Deluxe Apparels Ltd.

14/ka, Ring Road, Shyamoli Dhaka
(23.766189 N, 90.341436E)

25th February 2015

3rd floor

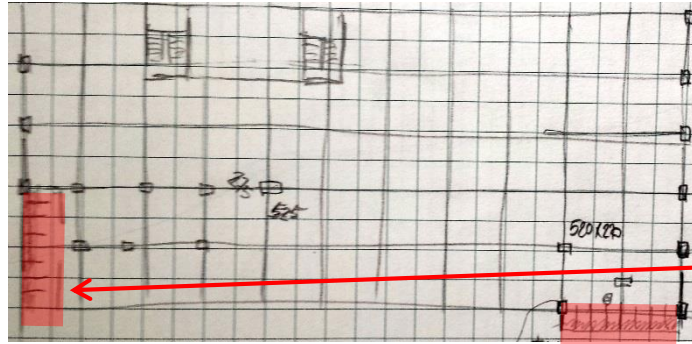
Columns appear to be stressed in excess of normal design limits

Cursory calculations indicate that column working stresses for internal columns and columns in the toilet areas are in excess of normal design limits.

1st floor

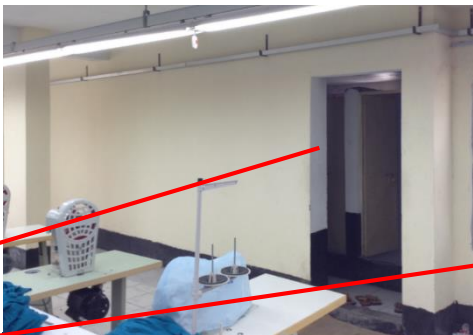
High toilet build-ups 90 mm

Boiler on 1st floor

1st floor plan

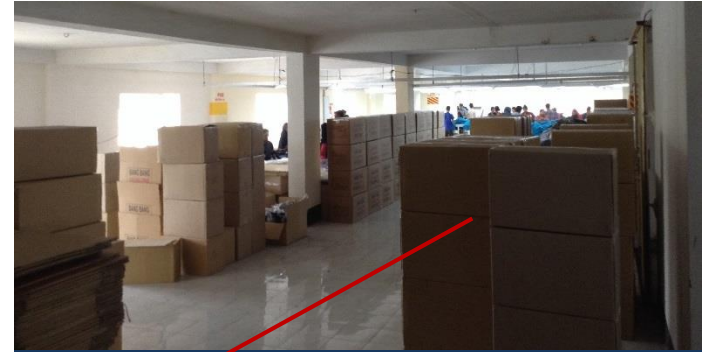
Storage loading on the 1st floor

Column Stresses

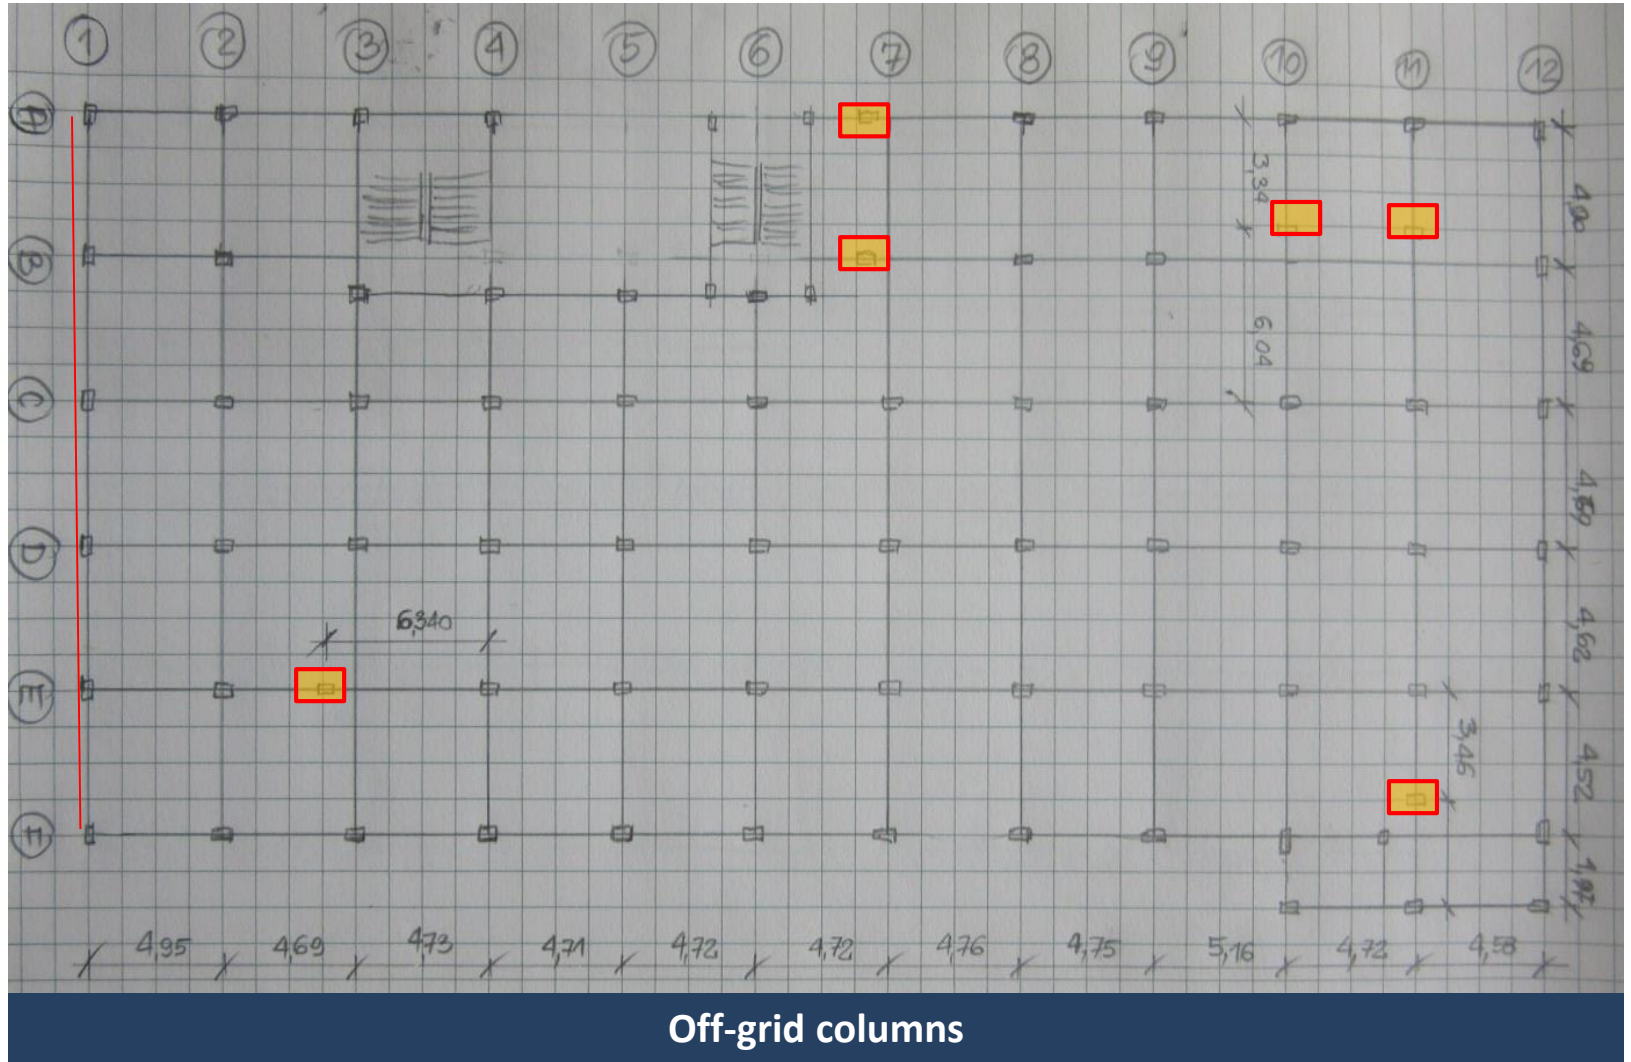
Lack of Permit Drawings, Design Drawings or Loading Plans

Inconsistent Column Grids

Enclosed Staircases

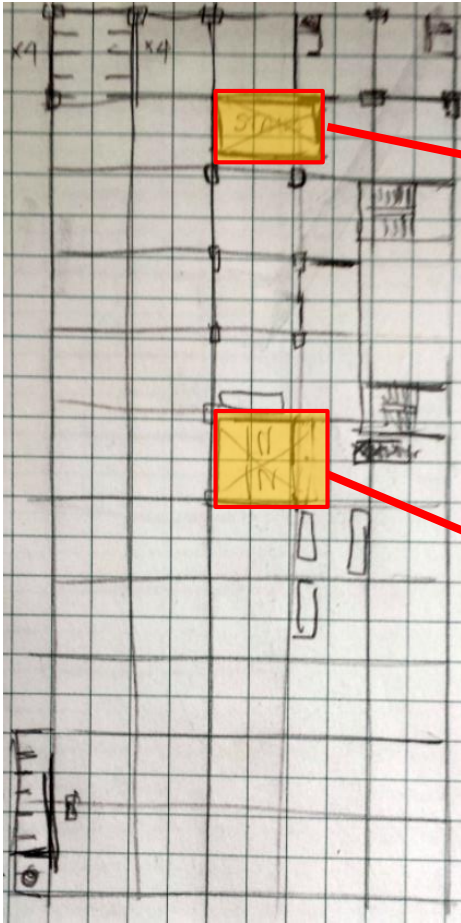
Two staircase constructed up to 1st floor and closed by fence walls
